## ADDENDUM NO. 1

MUSCOY ELEMENTARY SCHOOL – ADMINISTRATION OFFICE AND LIBRARY MODIFICATIONS

SAN BERNARDINO CITY UNIFIED SCHOOL DISTRICT  
777 North F Street  
San Bernardino, CA 92410

DSA No. 04-115436      File No. 36-55

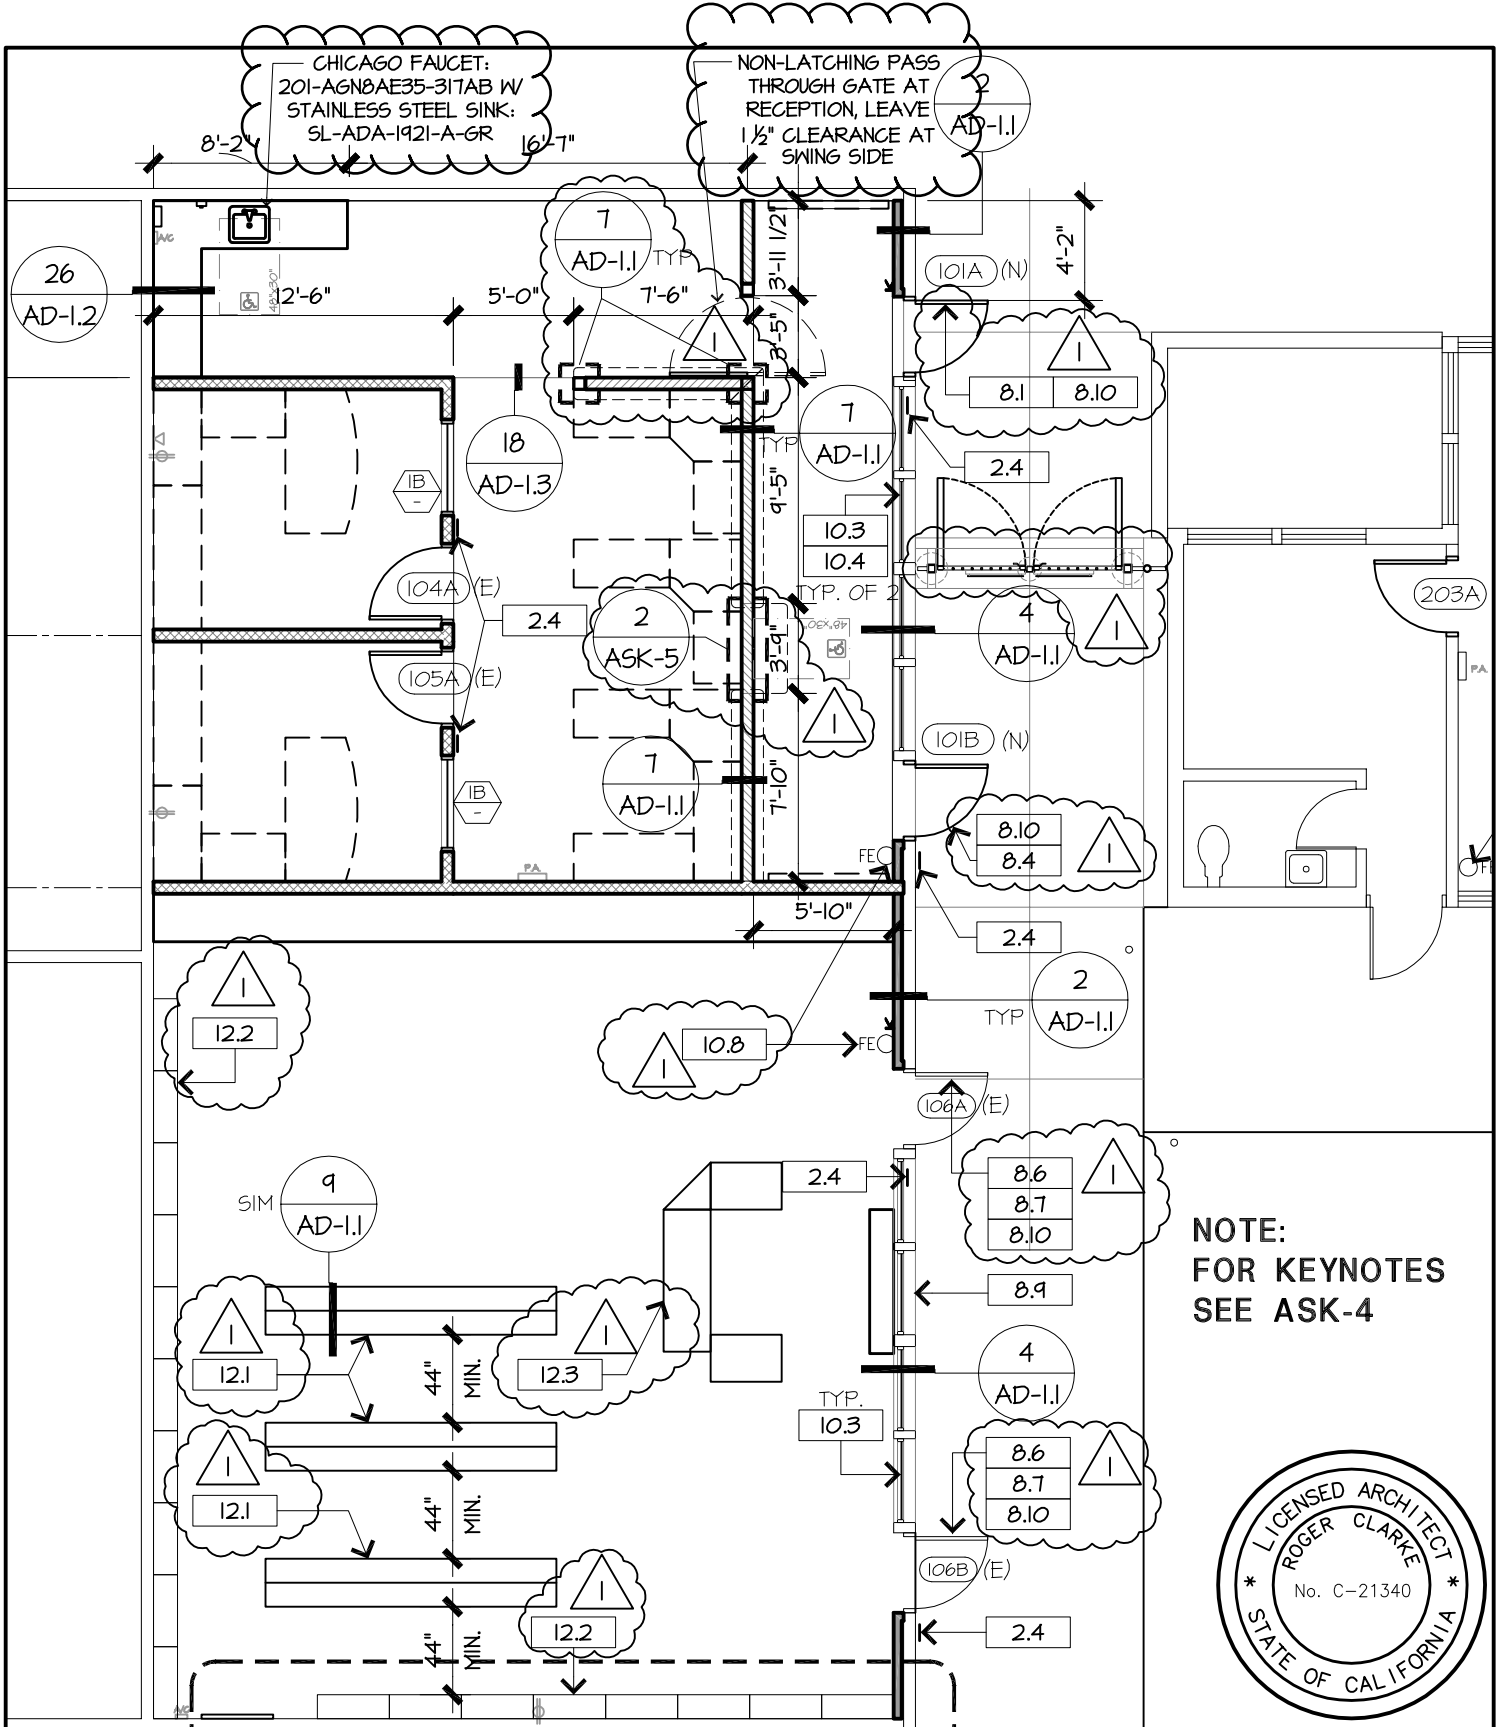
- Item No. 1.3      Reference Sheet AS-1.2 Enlarged Demo and Site Plan:
- 1.3.1      Detail 9, add hatch pattern at entry for area to receive new concrete per attached Sketch ASK-1.

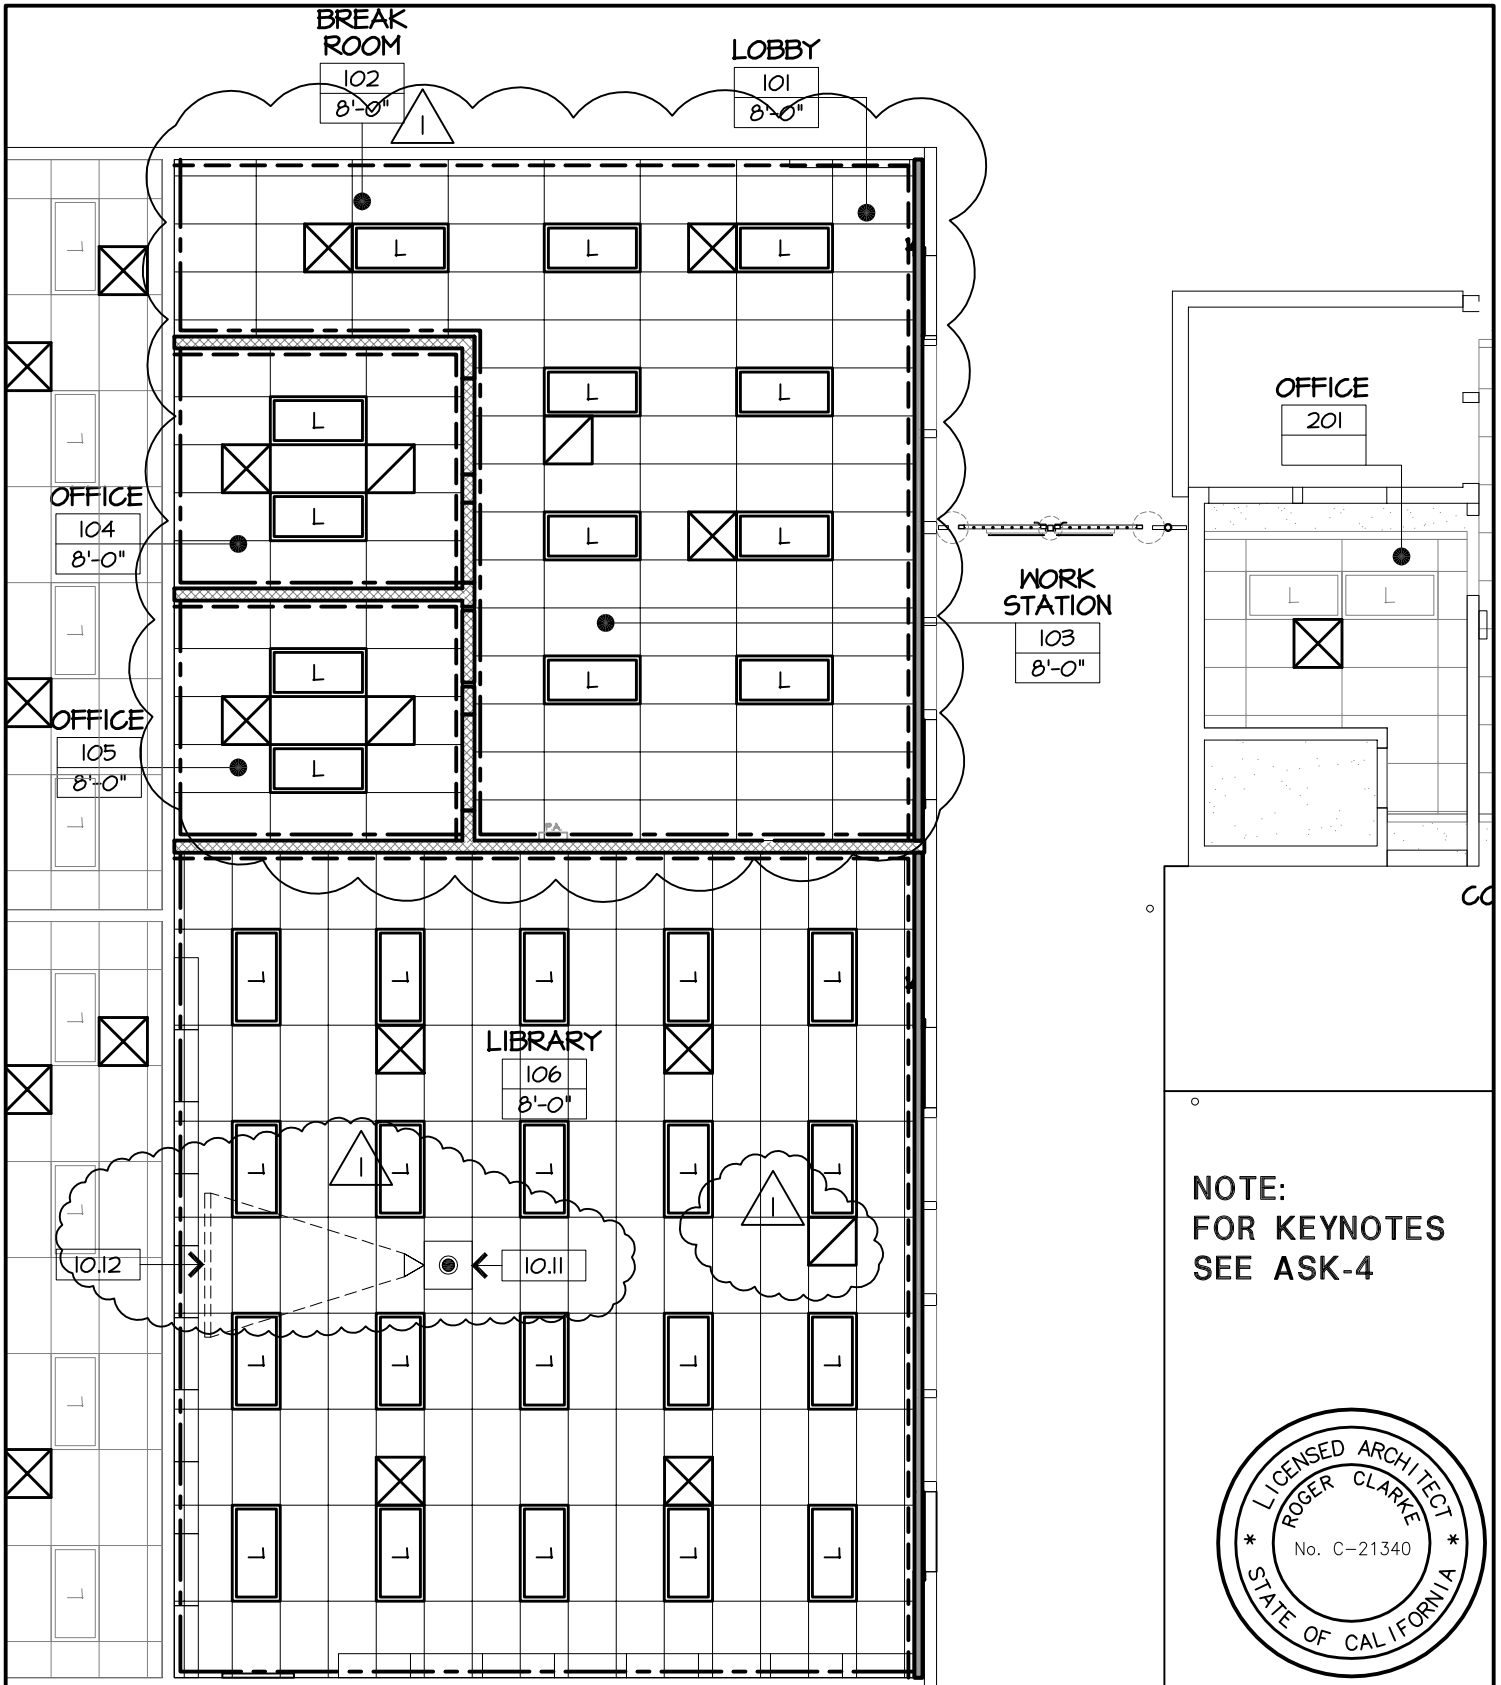
- Item No. 1.5      Reference Sheet A-1.2 New Floor & Reflected Ceiling Plan:
- 1.5.1      Detail 8, revise Floor Plan per attached Sketch ASK-2.
  - 1.5.2      Detail 10, revise RCP per attached Sketches ASK-3 and ASK-4.
